BRIEFING SUMMARY SHEET

DEVELOPMENT ASSESSMENT CASE NUMBER: CD-2020-0001

Presentation of a Development Assessment Report for the Springdale Green Planned Unit Development (PUD) located at 1011 and 1017 Springdale Road. The property is east of the intersection of Airport Boulevard and Springdale Road within the Boggy Creek and Tannehill Branch watersheds.

LAND USE PLAN

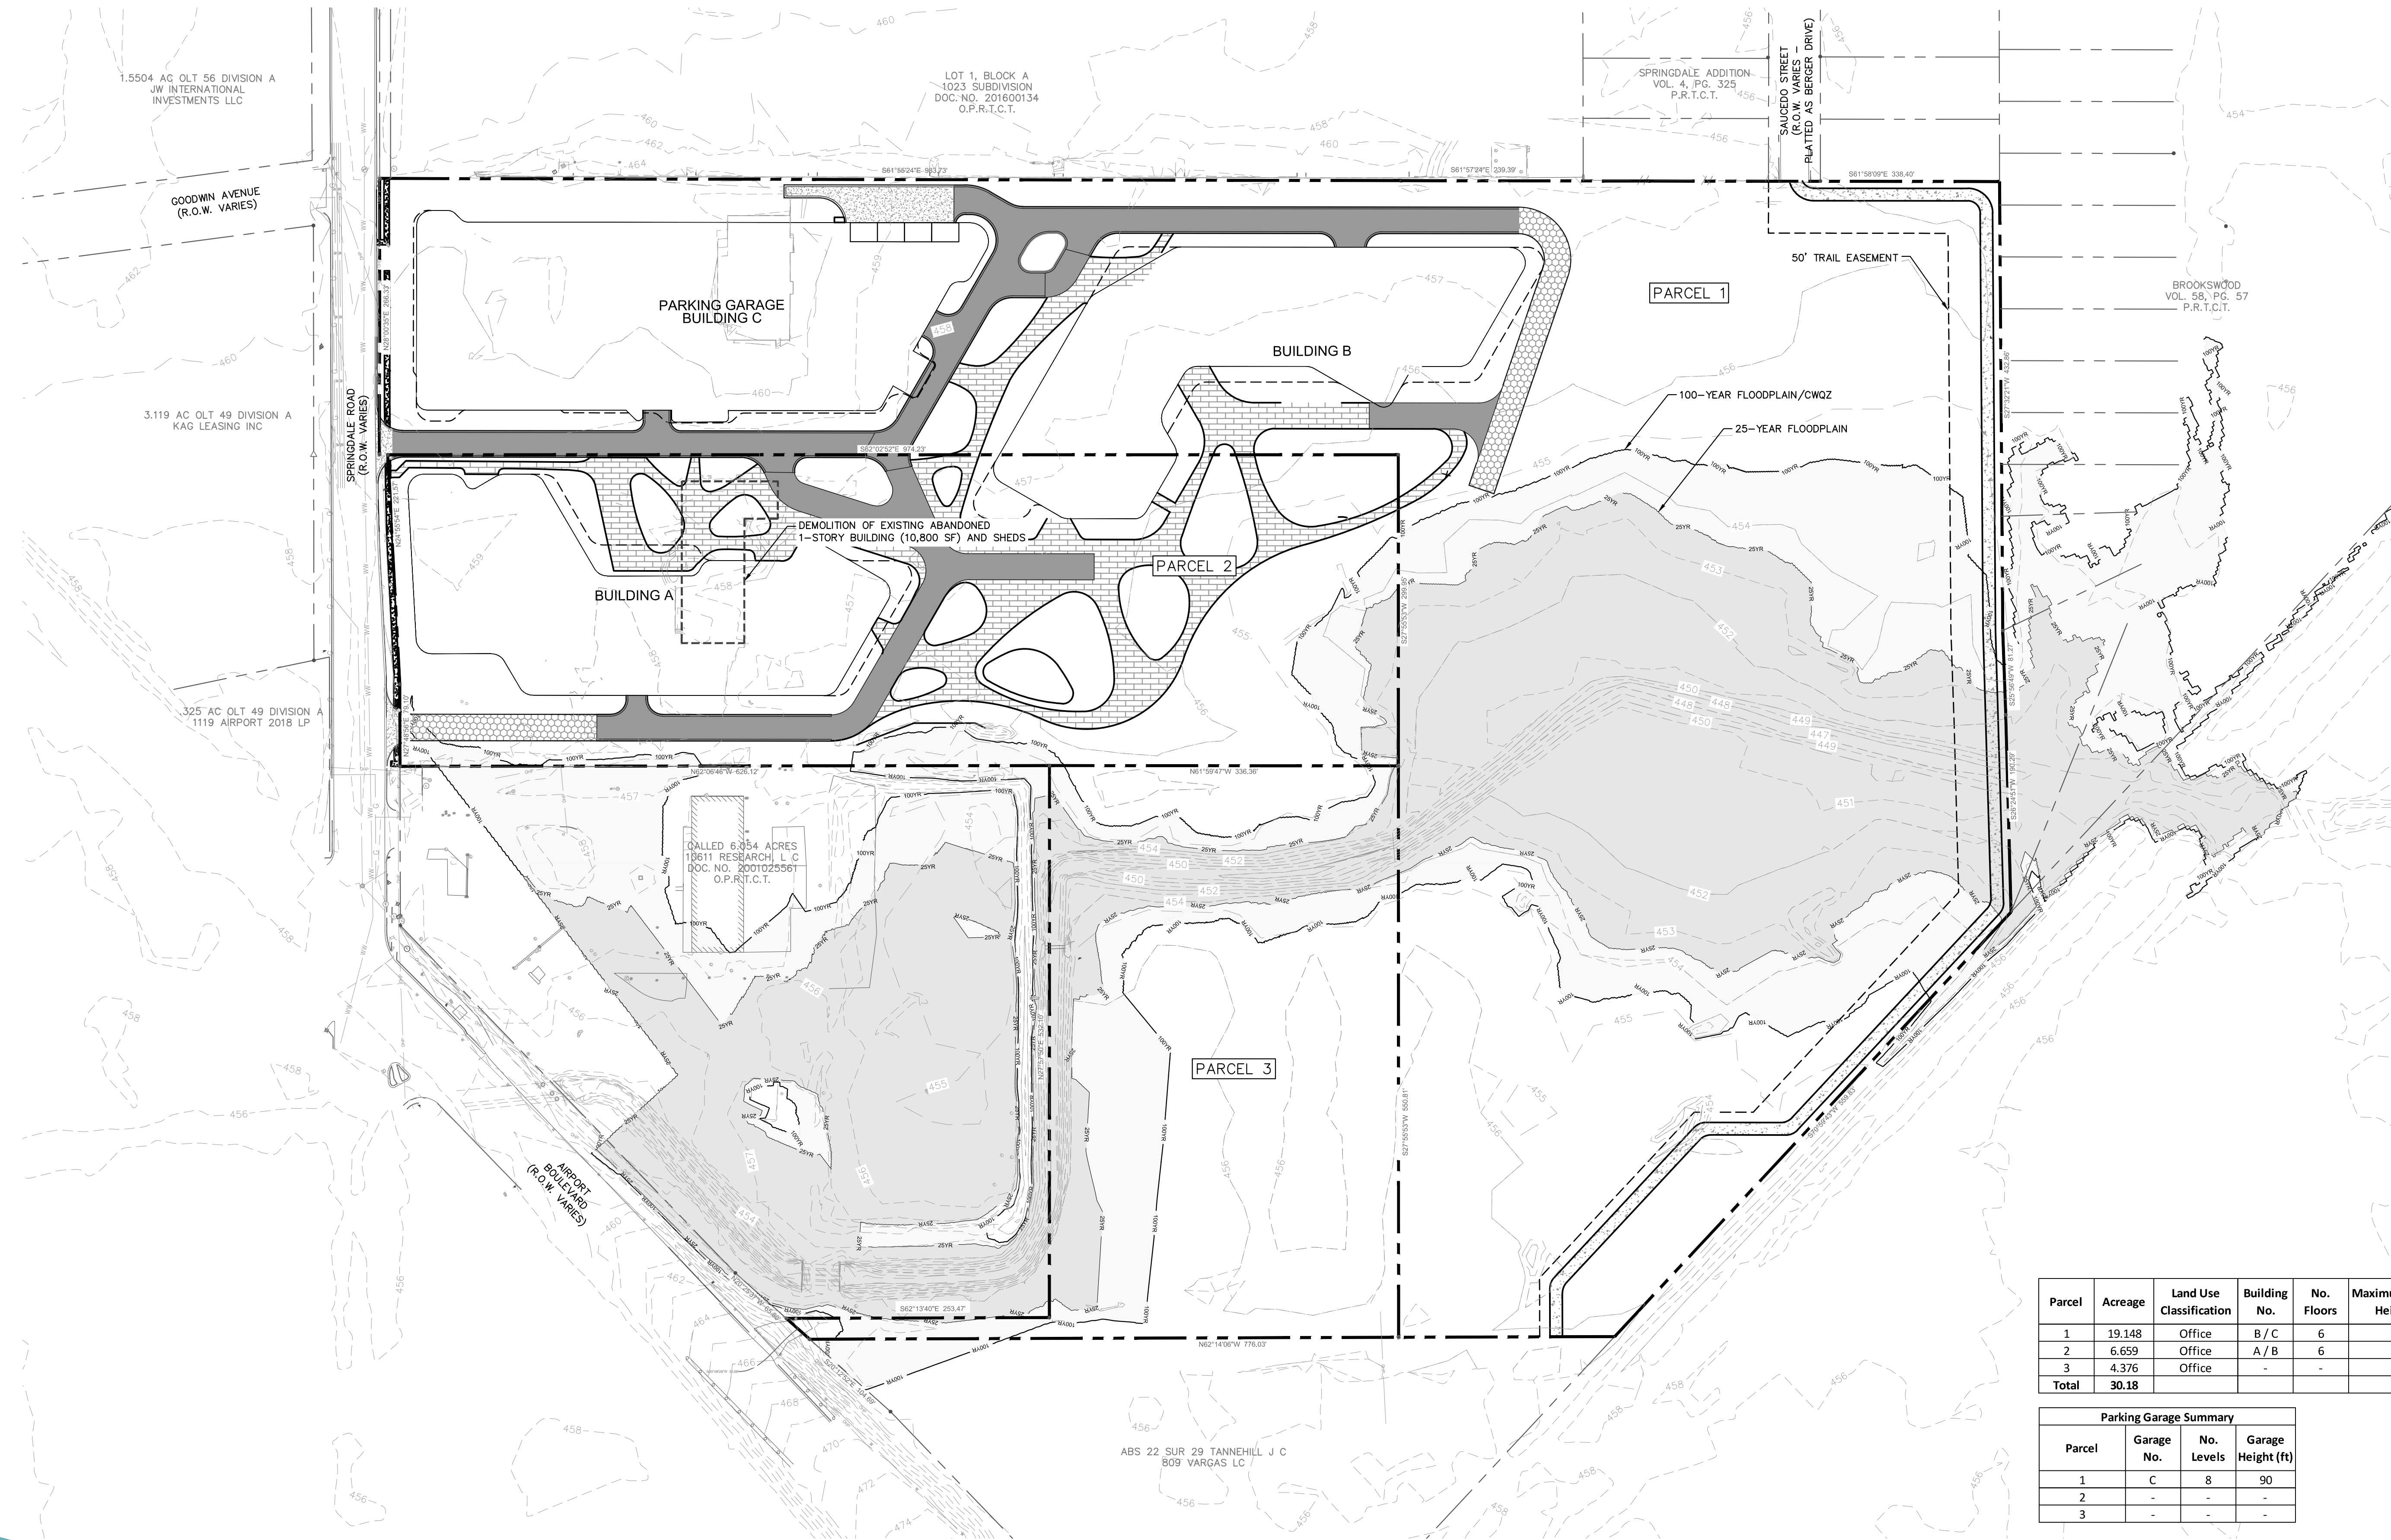
EV 3 Show and locate the proposed environmentally superior water quality controls on the Land Use Plan, and demonstrate how their location meets or exceeds the minimum requirements of current code. If code modifications or exemptions are being sought for the location of water quality controls, indicate how the proposed modifications or exemptions meet Tier II Superiority requirements.

EV 7 For the proposed fire lane construction, show the proposed locations on the Land Use Plan and demonstrate that this delineation does not exceed or seek to modify that which is allowed by code unless adequate Tier II Superiority is proposed. Per ECM 1.8.1., unpaved driveways compacted by vehicular use shall be considered impervious cover. Demonstrate with the PUD proposal how the proposed fire lanes meet or exceed Tier II Superiority requirements.

DE 1. A detailed review cannot be made at this time because the information provided on the land plan does not meet the application requirements. See the application packet for future submittals.

DE 3. This development contains the floodplain. Delineate the 25 and 100 year floodplain for upstream fully developed conditions as specified in LDC 25-7-6. If floodplain modifications are proposed, delineate the floodplain for both existing and proposed conditions. Provide a floodplain study to substantiate the floodplain delineation with sufficient detail for review.

DE 6 Drainage facilities containing the floodplain and enclosed or open drainage facilities will need to be contained within the ROW or easements as specified in LDC 25-7-152. Delineate all proposed easements and ROW on the land use plan and provide schematic drainage plan substantiating the layout of the subdivision.

WB6. Update0. The floodplain depicted in the Land Plan does not appear to be consistent with the floodplain known to this reviewer per COA GIS. Please resolve.

WB7. Update0. Plans and discussions as of the time of this comment have indicated substantial modifications (both vertical and horizontal) to the COA 100yr fully developed floodplain, however, these aspects of the applicant's plan do not appear on the Land Plan. Please resolve.

SP5. Please include the following on the land use plan:

TR4. For non-residential uses, a land use plan must include, the number of curb cuts or driveways, which must be the minimum necessary for adequate access to the site. Please explain why the second fire access is necessary. Is this request coming from fire? If not gated, how will public access be prohibited?

ATD4. As previously discussed, the second drive is not supported or approved at this time; please remove it from the PUD land use plan.

4. Provide documentation of all approved environmental remediation on the property.
5. LAND USE PLAN:
6. Identify baseline zoning category on land use plan (LUP). List existing zoning categories and label the location of each on the drawing.

7. List gross square feet/acreage.
8. Label surrounding zoning and existing land uses.
9. Provide a site location map.
10. Are you proposing to modify the list of permitted land uses? For example, automotive land uses may not be appropriate on this brownfield site. If so, list on LUP near baseline zoning category.

11. Label the trail easement as "public trail easement".
12. Show and label all existing and proposed easements, as well as easements to be vacated with recording info.

13. Show/label existing driveways.
14. Note #1- All information regarding building square footage must be in terms of gross building square footage (s.f.). Leasable s.f. is not a COA zoning enforceable term.

15. Note #2- Spell out floor-to-area ratio. Specify that it's a maximum 50% impervious cover (IC) for the gross site area.
16. Note #3- Further discussion will be necessary regarding how much deviation from a PUD LUP is permitted. PUDs typically do not show the level of detail shown on this LUP, particularly in regards to sidewalk locations. It is understood that all buildings, parking, etc. must be reviewed in detail and comply with COA code at time of site plan.

17. Table: Add "commercial" to the Land Use classification. It is Staff understanding that ground floor commercial is proposed.
18. Table: Remove "building height" column; keep max building height column.

19. Table: Label “maximum” number of floors.
20. Table: In addition to clarifying in the notes section, clarify in the table or nearby the maximum gross building s.f. It may be necessary to remove detailed information about “approximate” s.f. PUDs establish minimum and maximum levels; details could lead to future PUD amendments.
21. Parking Garage (PG) Table: Label building height/levels as maximum.
22. A Carbon Impact Statement will be required. The form is attached. Contact Caitlin Admire in the Office of Sustainability with any questions; submit the Carbon Impact Statement to the Zoning Case Manager at time of formal PUD submittal.
